**CASE NO. FP-2026-0015
ORDER OF CONDITIONAL
APPROVAL OF FINAL PLAT**

HEARING DATE: 7/7/2026
TO: Mayor & City Council
FROM: Nick Napoli, Associate Planner
208-884-5533
SUBJECT: Windrow No. 3
FP-2026-0015
LOCATION: Generally located at the NEC of S. Linder Road and W. Amity Road (Parcels #S1225347078, #S1225325700, #S1225336520, #S1225336505., in the SW 1/4 of Section 25, T.3N., R.1W.

Final Plat consisting of thirty-seven (37) building lots and eight (8) common lots on 7.92 acres of land in the R-8 zoning district for the third phase of Windrow Neighborhood Subdivision.

A. Preliminary Plat (dated: 9/13/23)

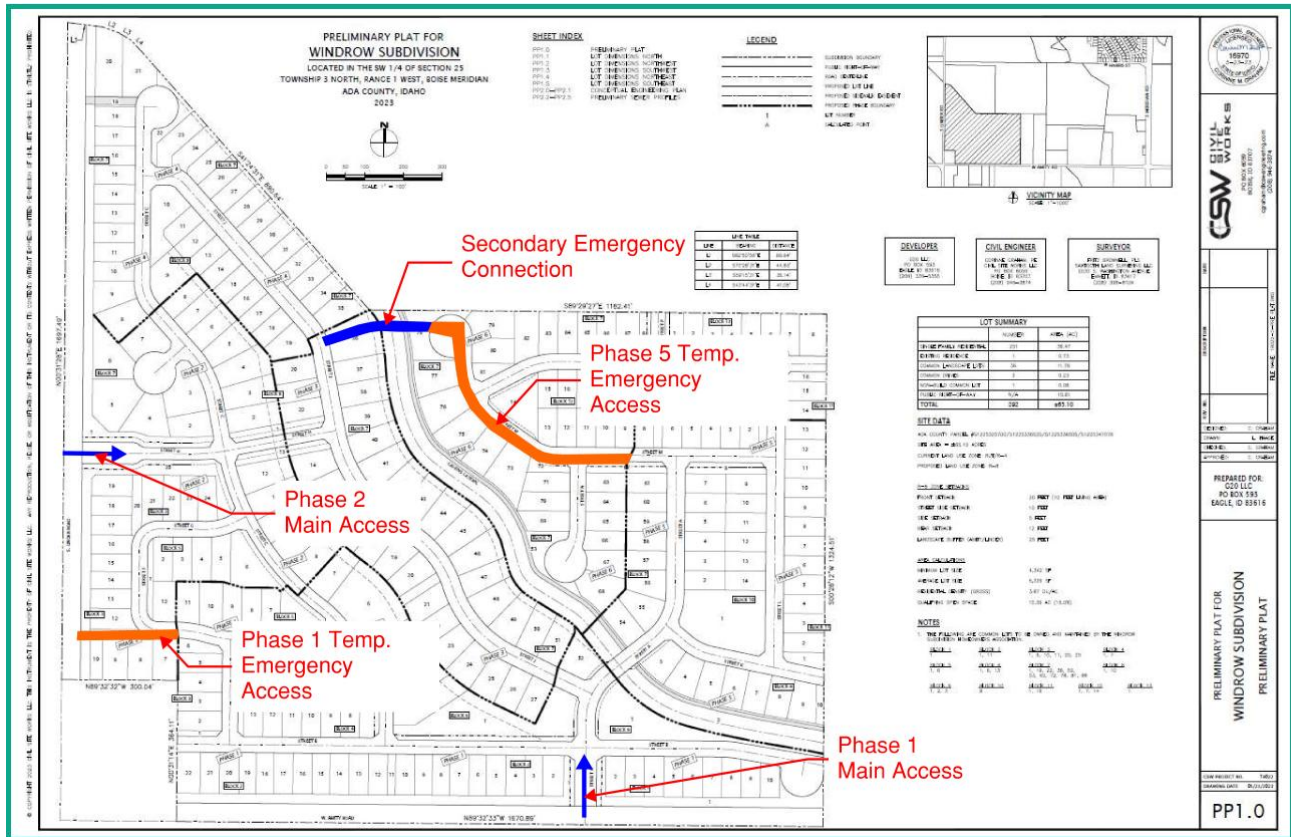
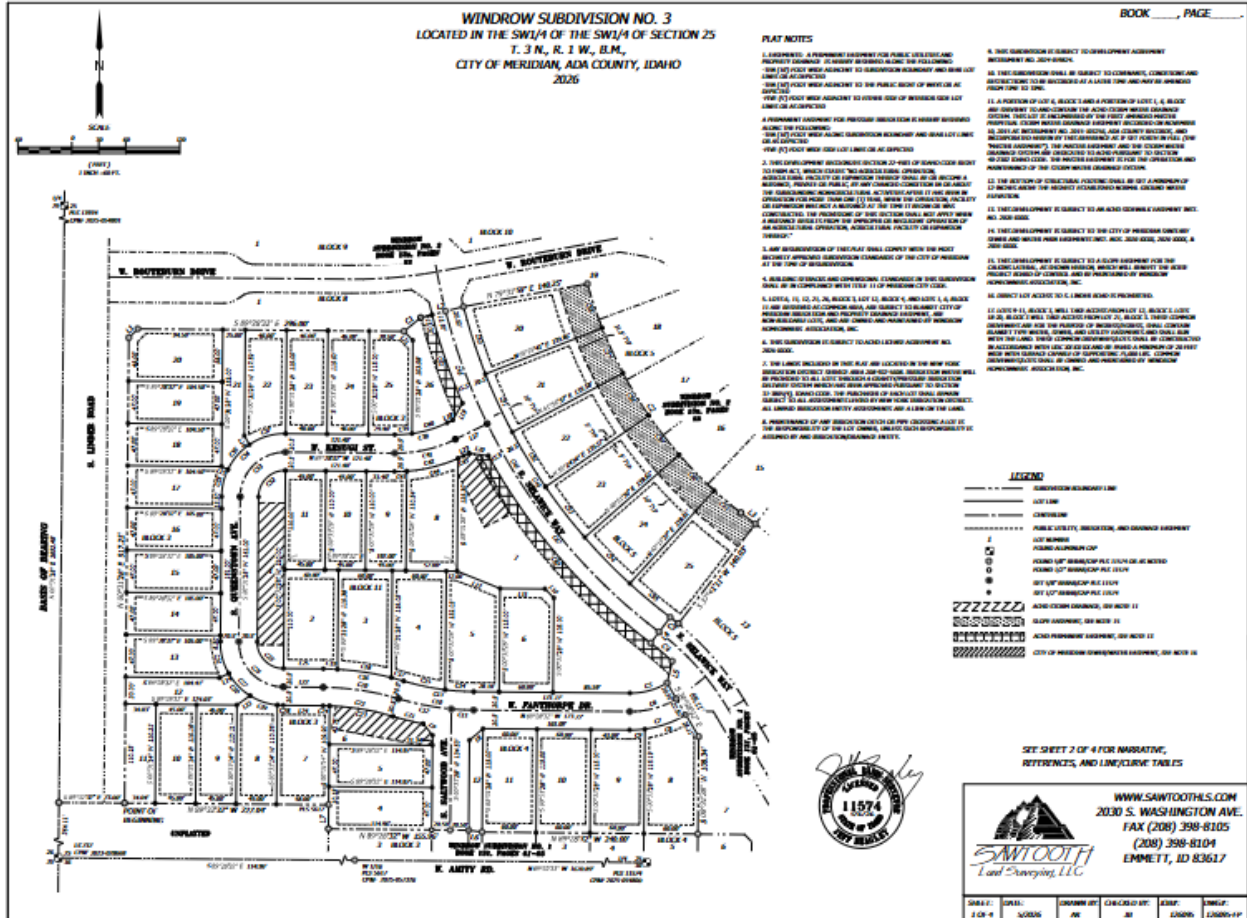
While the proposed final plat includes minor modifications to the road alignment and open space configuration, these changes do not affect overall compliance with the approved preliminary plat. Additionally, the applicant has reduced the number of buildable lots in this phase by one (1) compared to the preliminary plat. The applicant also revised the phasing to allow required access points to be constructed in different phases. Although this represents a deviation from the approved phasing plan, staff has discussed the modification with the applicant and determined that the change is primarily driven by market demand considerations and the desire to provide a second access point to the subdivision.

Because the number of buildable lots has decreased by one (1) and the amount of common open space has increased slightly, staff finds that the proposed final plat remains in substantial compliance with the approved preliminary plat, as required.

B. Final Plat (dated: 5/06/26)

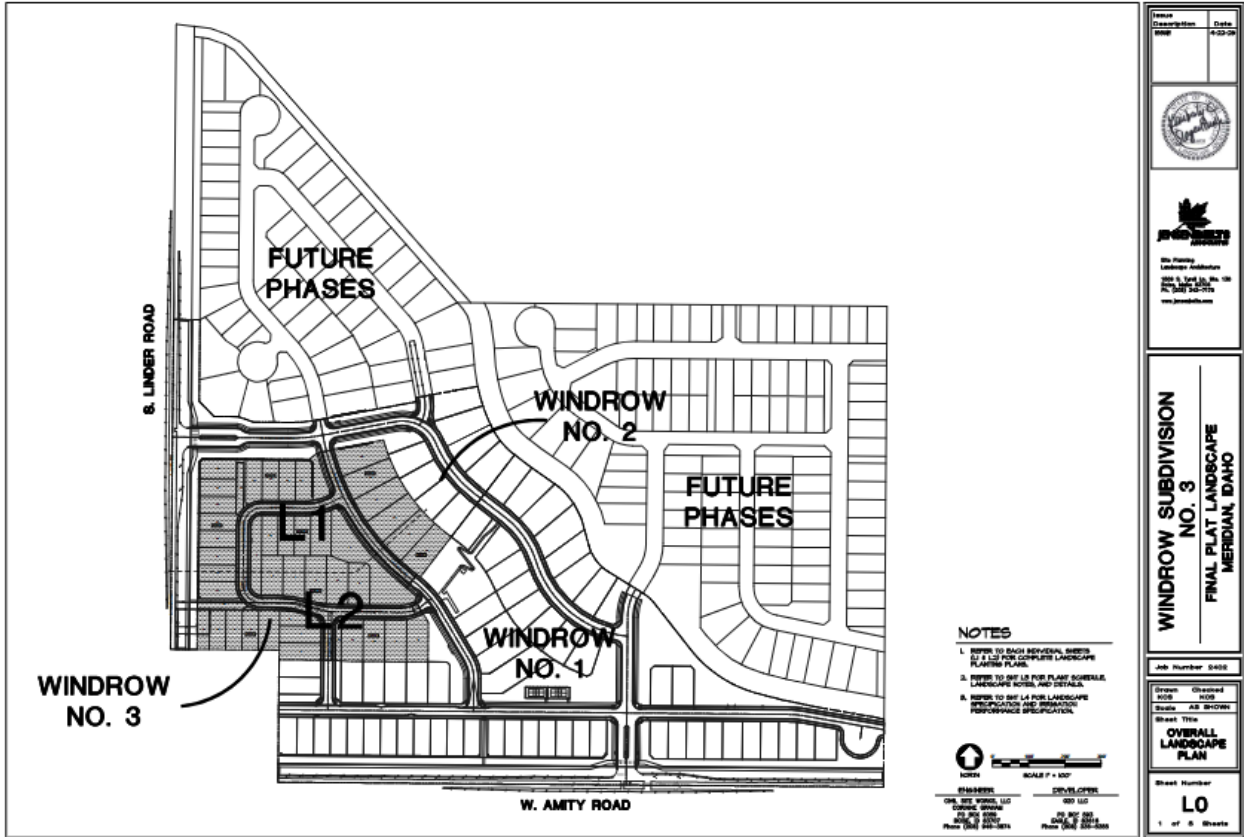
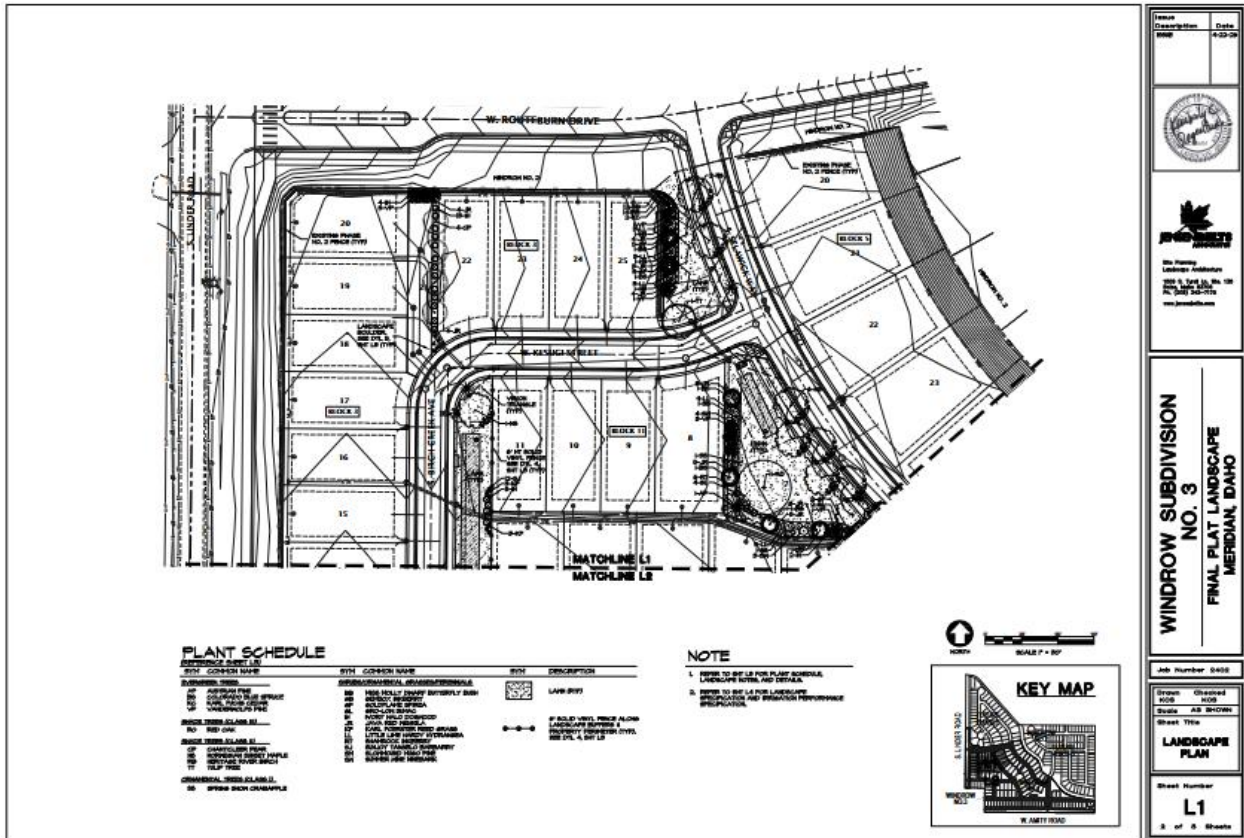
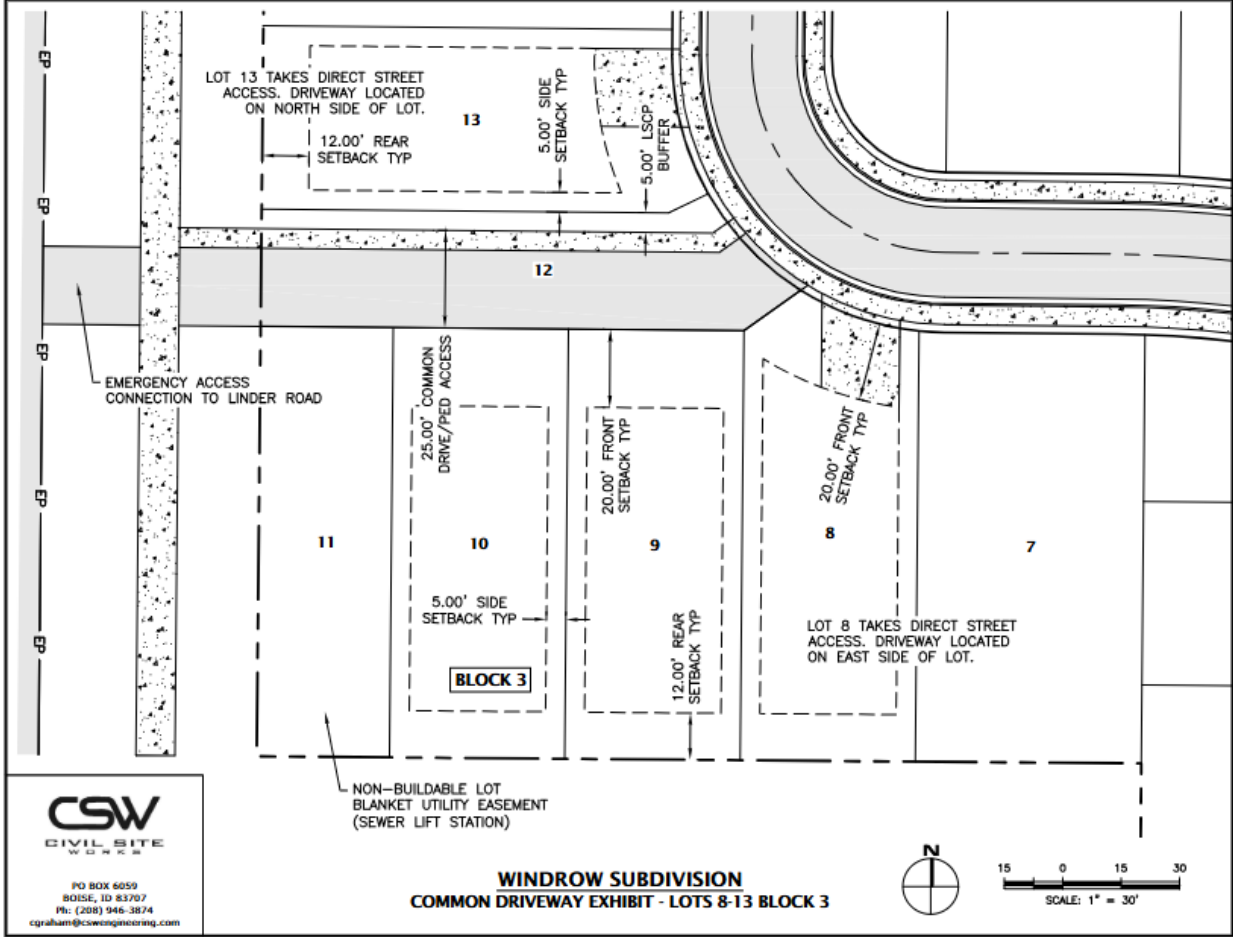
3. Prior to submittal for the City Engineer's signature, have the Certificate of Owners and the accompanying acknowledgement signed and notarized.
4. The final plat prepared by Civil Site Works, dated: 11/2/2023, included in Section V.B shall be revised as follows:

- a. Note #6: Include the recorded instrument number for the ACHD license agreement.
 - b. Note #13: Include the recorded instrument number of the ACHD sidewalk easement.

- c. Note #14: Include the recorded instrument number of the City of Meridian Sanitary Sewer Easement.
 - d. Confirm the fencing around the lift station is 6-foot closed vision fencing.

- e. Confirm the type of traffic calming along Selawick Way.

A copy of the revised plat shall be submitted with the final plat for City Engineer signature.

C. Landscape Plan ((dated: 04/22/2026)

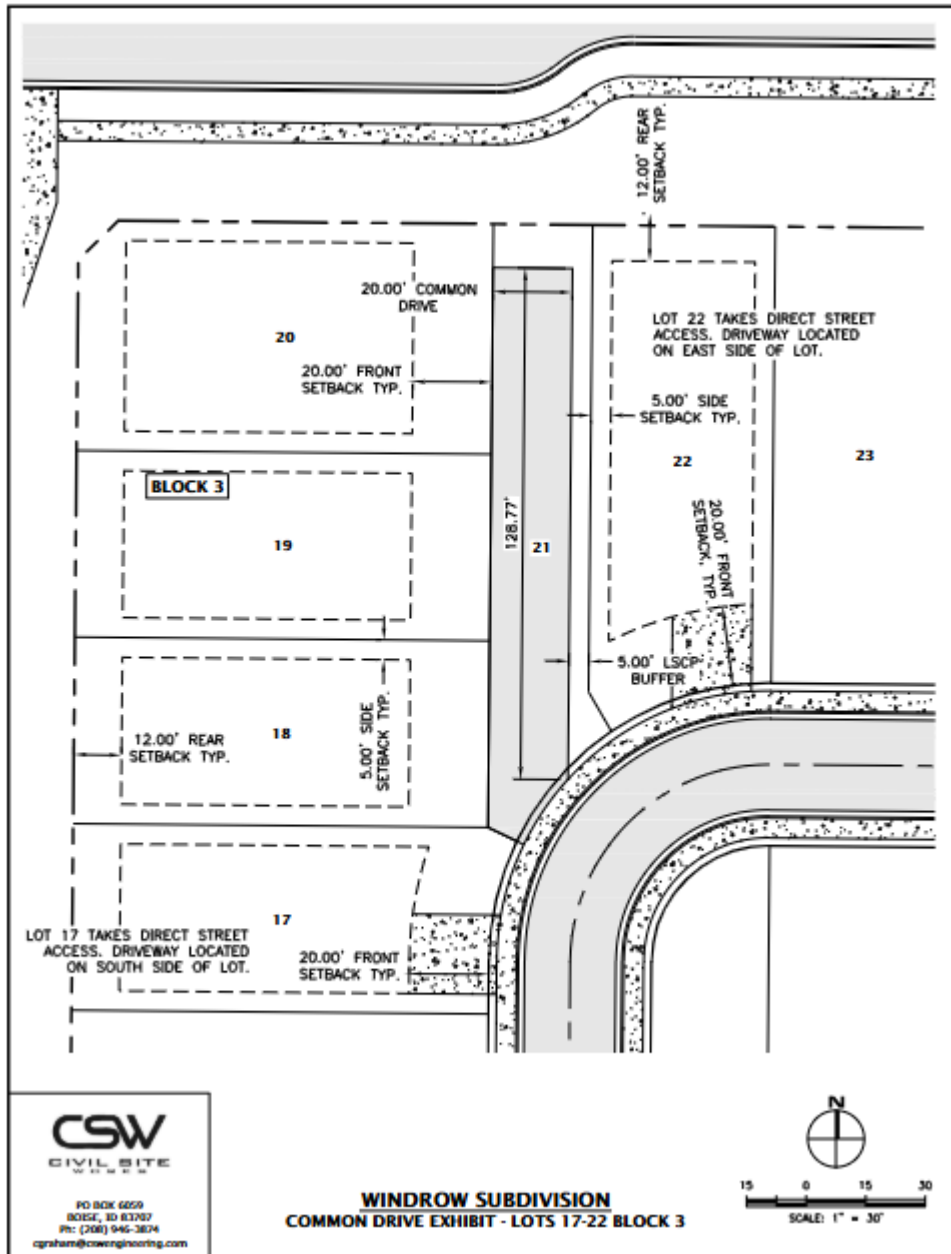
5. The landscape plan prepared by Jensen Belts, dated 4/22/2026, included in Section V.C, is approved as presented.
6. The rear and/or sides of home visible from S. Linder Road (Lots 11, 13-20, Block 3) shall incorporate articulation through changes in two or more of the following: modulation (e.g., projections, recesses, step-backs, pop-outs), bays, banding, porches, balconies, material types, or other integrated architectural elements to break up the monotonous wall plane and roof line that are visible from the subject public street. Single-story structures are exempt from this requirement.
